**IEEE 802.3dg**

**Task Force**

**100BASE-T1L MDI RL**

Steffen Graber

# MDI RL Simulation (Trunk Port, simplified Circuit)

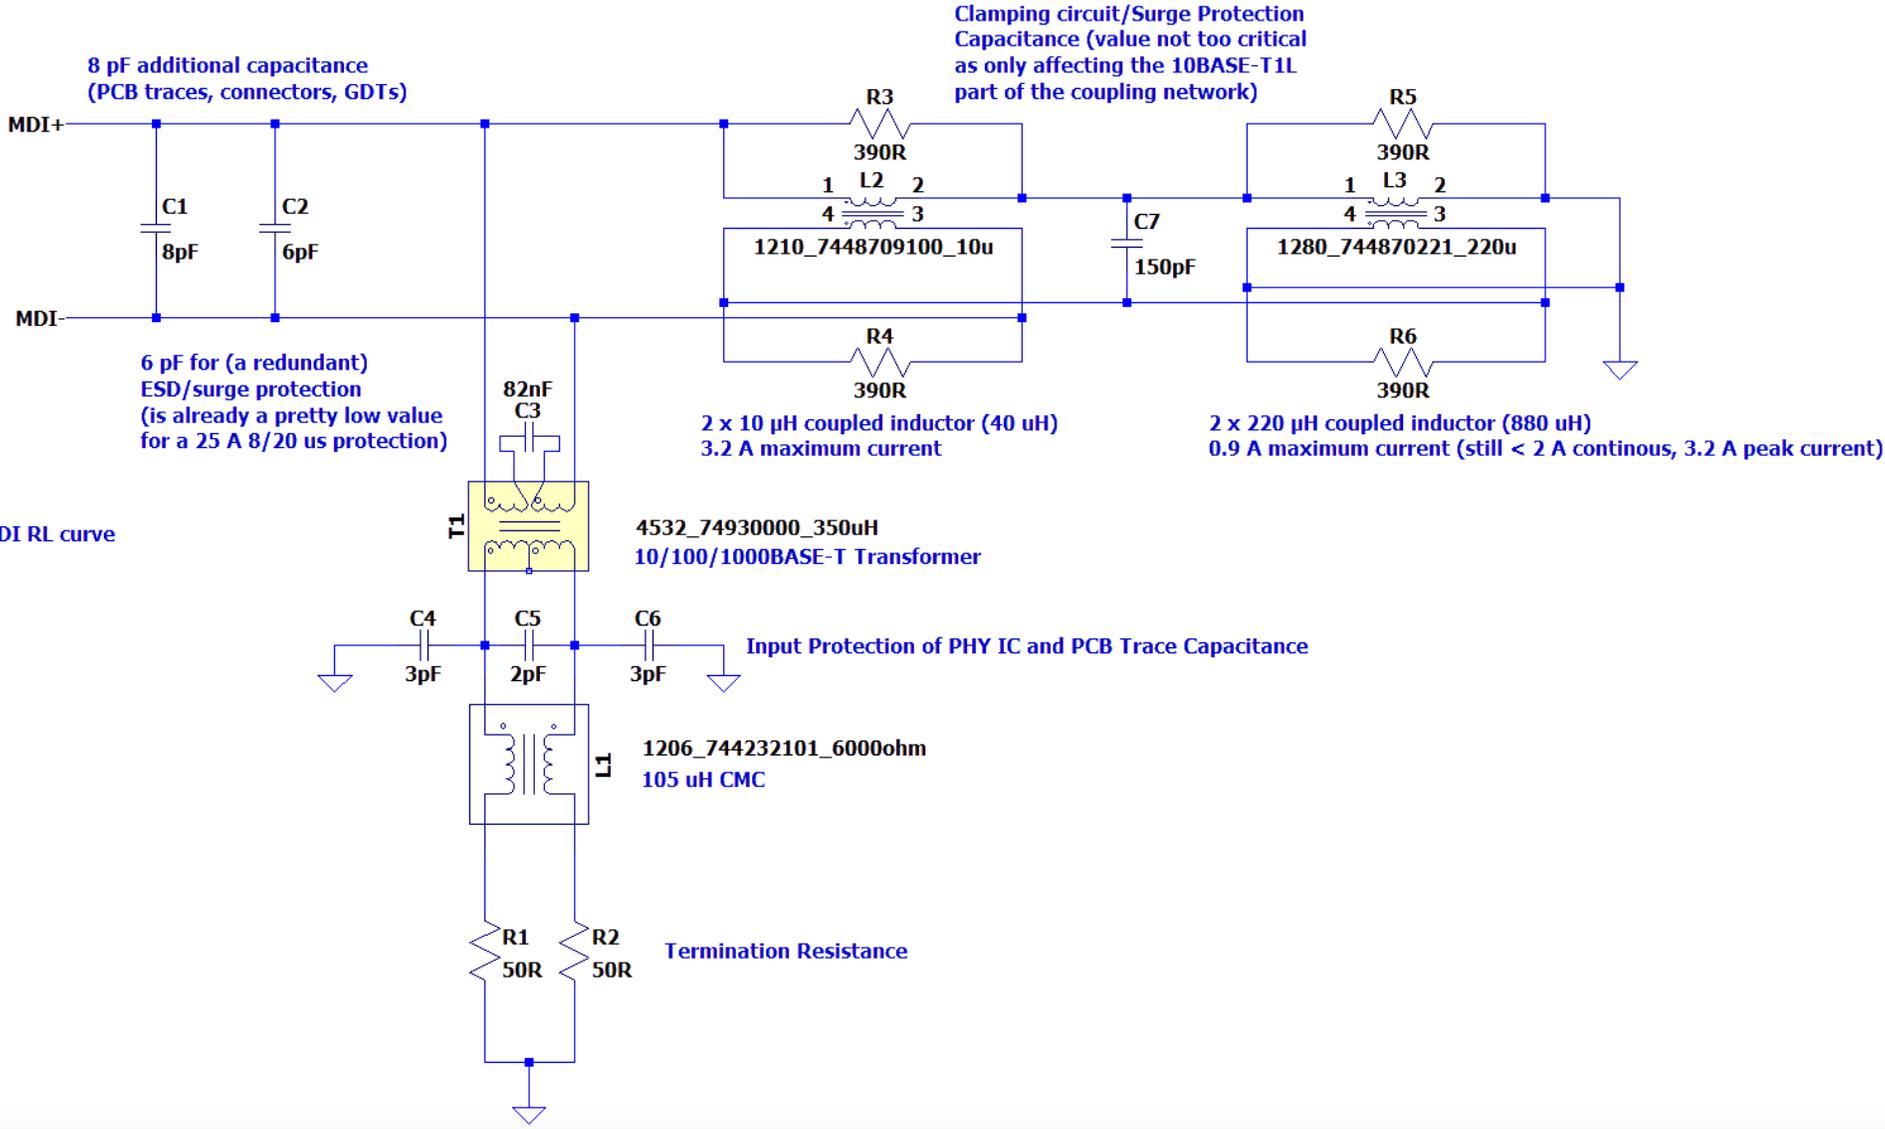
- The MDI RL has been defined based on the 1000BASE-T MDI RL specification, as appropriate isolation transformers are commonly available.
- In powered systems additionally to the isolation transformer further inductors and likely also a common mode choke for the power coupling network are necessary.
- These inductors have relatively high internal parasitic intra- and interwinding capacitances, which influence the MDI RL, especially in the higher frequency range.
- Due to the high current, e.g. flowing on an Ethernet-APL trunk, a significant amount of energy can be stored in the power coupling inductors, which needs to be dissipated in the clamping/EMC protection circuit in case of a freewheeling event.
- This causes the need for larger protection elements, providing a higher parasitic capacitance.

# MDI RL Simulation Result

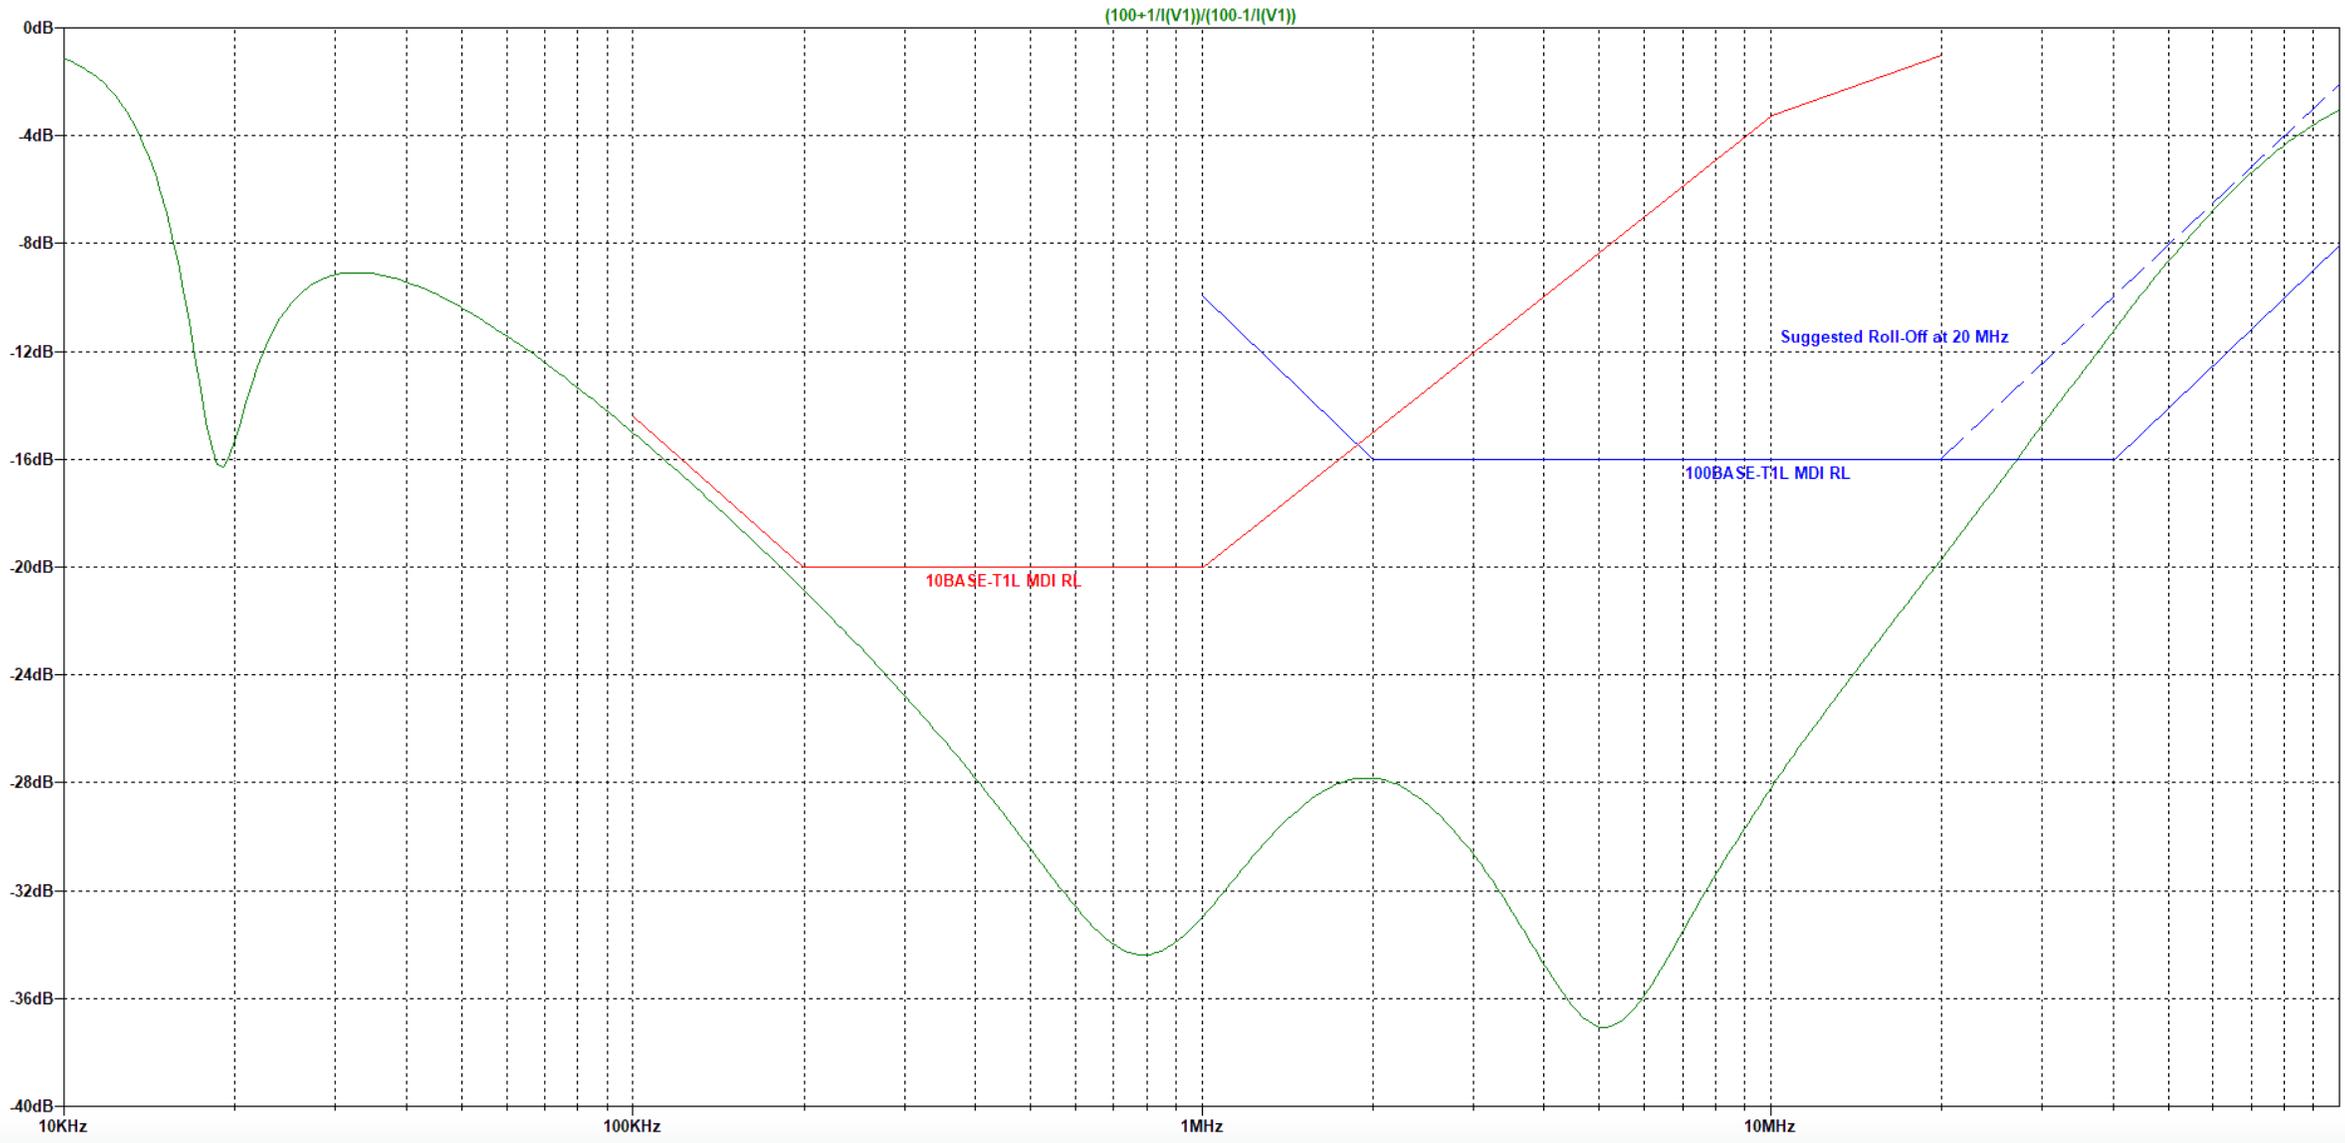
- As it can be seen on the previous slide, even when trying to minimize the capacitive load, for a practical implementation the 40 MHz corner frequency of the MDI RL specification is expected to be too high.
- Therefore, it is suggested to reduce the corner frequency from 40 MHz to 20 MHz.
- This leads to higher reflections at the MDI and thus a reduced signal energy at the receiver.
- Nevertheless, changing the corner frequency from 40 MHz to 20 MHz, still would lead to a similar MDI RL at Nyquist frequency as for 10BASE-T1L (10.4 dB @ 3.75 MHz for 10BASE-T1L and 10 dB @ 40 MHz for 100BASE-T1L).
- The new suggested MDI RL limit would be:

$$MDI \text{ Return Loss} \geq \begin{cases} 16 \text{ dB} - 20 \text{ dB} \cdot \log_{10} \left( \frac{2 \text{ MHz}}{f_{\text{MHz}}} \right) & \text{for } 1 \text{ MHz} \leq f < 2 \text{ MHz} \\ 16 \text{ dB} & \text{for } 2 \text{ MHz} \leq f \leq 20 \text{ MHz} \\ 16 \text{ dB} - 20 \text{ dB} \cdot \log_{10} \left( \frac{f_{\text{MHz}}}{20 \text{ MHz}} \right) & \text{for } 20 \text{ MHz} \leq f \leq 100 \text{ MHz} \end{cases}$$
